Title-Sujet FOREST THINNING – SINCLAIR RESTORATION PROJECT IN KOOTENAY NATIONAL PARK		Date December 18, 2013
Solicitation No. - No. de l'invitation 5P424-13-0246/A	Amendment No. – No modif. 001	
GETS Reference No. – No de reference de SEAG N/A		
Solicitation Closes L'invitation prend fin – at – á 02:00 PM on – le Dec 24, 2013	Time Zone Fuseau horaire - Mountain Standard Time (MST)	
F.O.B. - F.A.B.		
Address Inquiries to: - Adresser toute demande de renseignements à :		
Eloise Meredith		eloise.meredith@pc.gc.ca
Telephone No. - No de téléphone (250) 347-6622	Fax No. – No de FAX: (250) 347-6621	
Destination of Goods, Services, and Construction: Destinations des biens, services et construction: Lake Louise, Yoho, Kootenay Field Unit Kootenay National Park		
Vendor/Firm Name and Address Raison sociale et adresse du fournisseur/de l'entrepreneur		
Name and title of person authorized to sign on behalf of the Vendor/Firm Nom et titre de la personne autorisée a signer au nom du fournisseur/ de l'entrepreneur

This amendment is raised to amend the Statement of Work and answer questions.

Map showing approximate limit of work for the Demolition contractor as well as the portion of the Demolition site around the old lodge which is excluded from the thinning work.

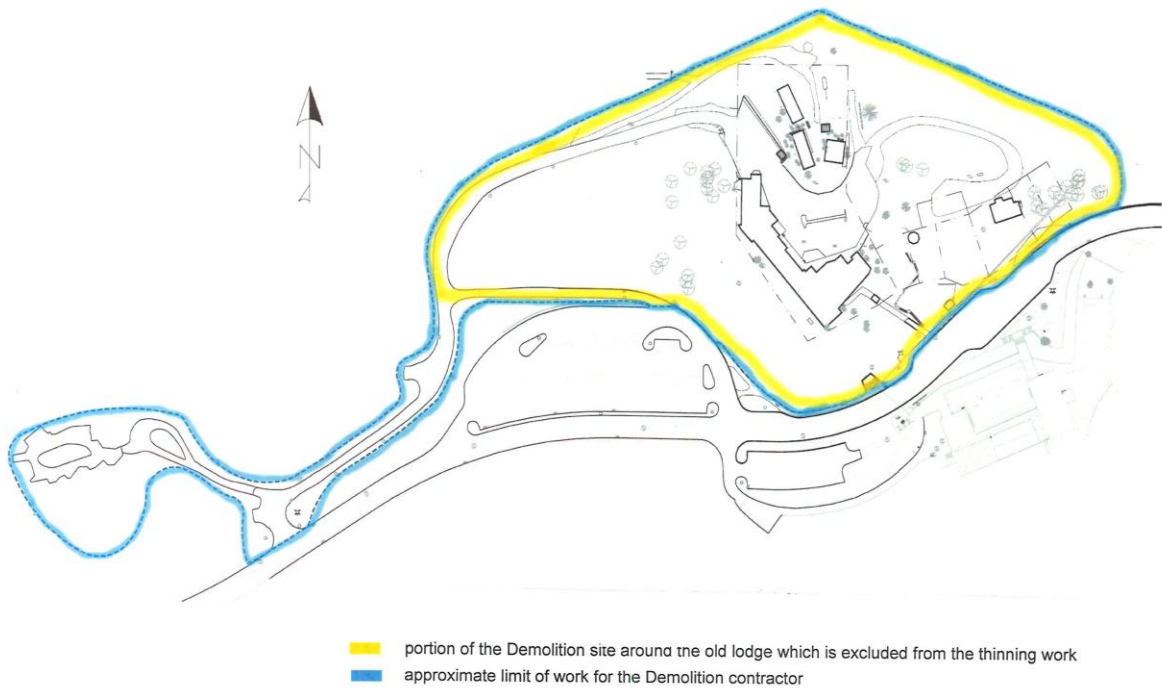
2 Can a map of the demolition work area be sent out?
Yes. See attached map.

5 Will an area around the Radium Hot Springs Lodge be excluded from the treatment area?
Yes. See attached map.

Figure 2. Sinclair restoration unit (45ha) with the unit boundary shown as a red line. Yellow shaded area indicates the mechanical thinning Treatment Units required of this contract (15.3 ha total) and green shaded area indicates the guard units (not within the terms of this contract).

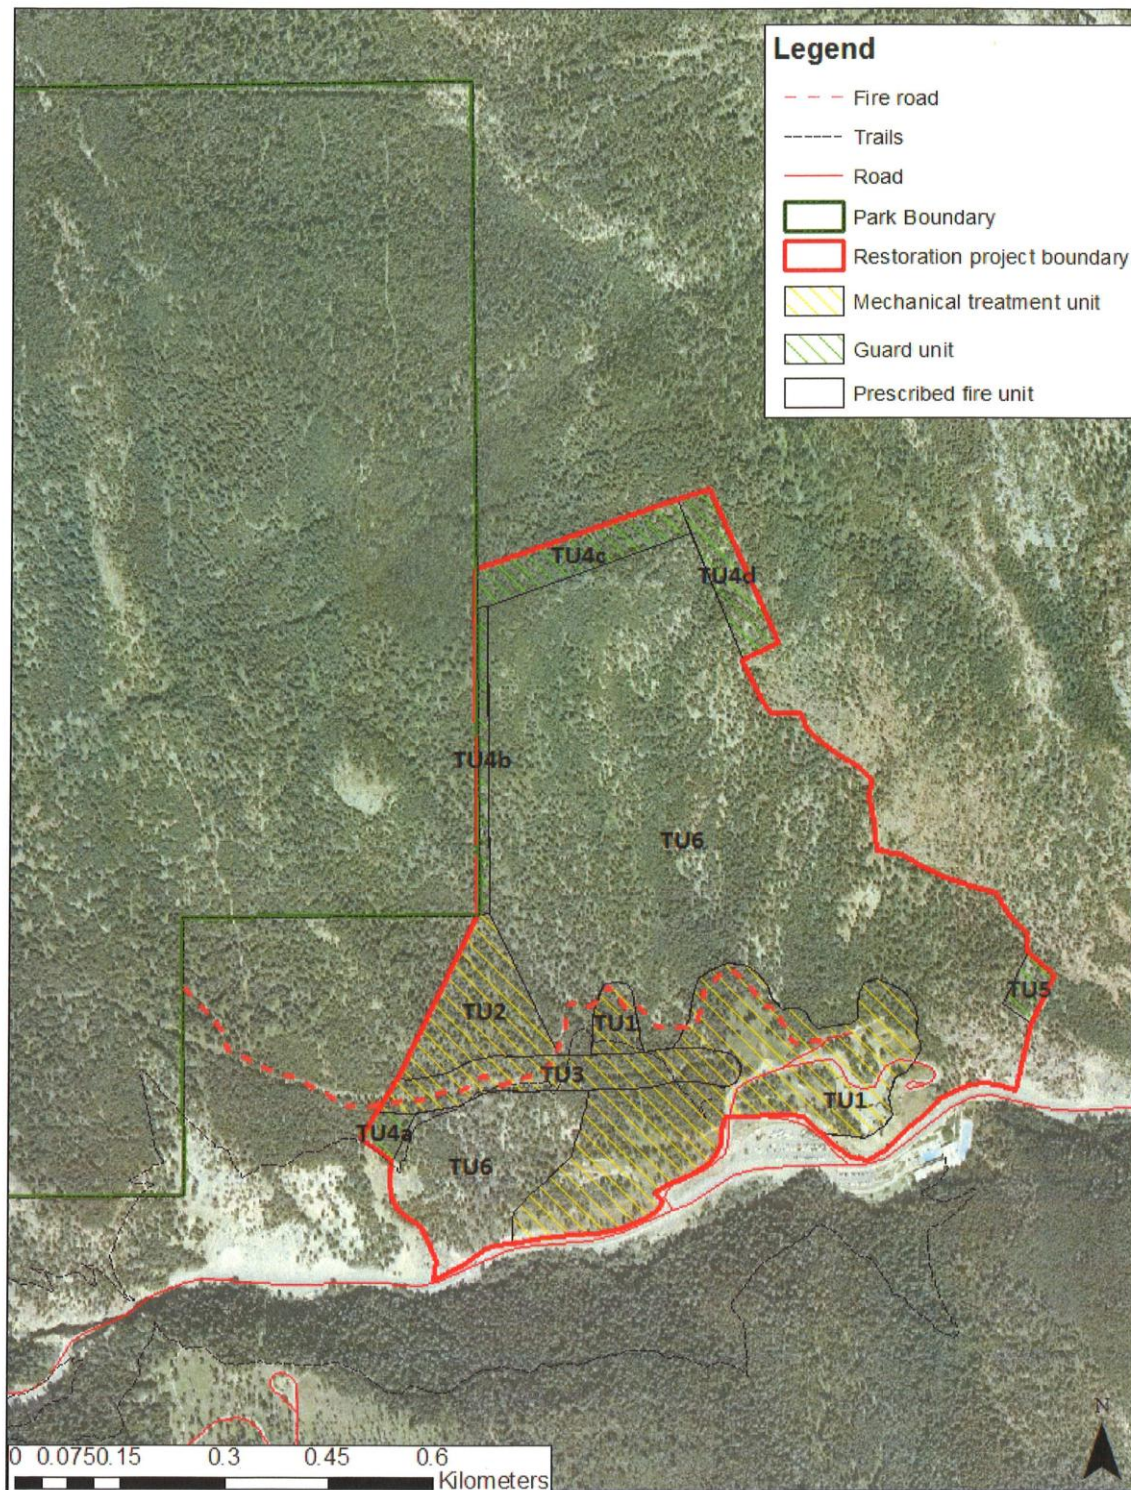
Remove
Figure 2, 6 and 7

Replace with
Figure 2, 6 and 7 attached below.
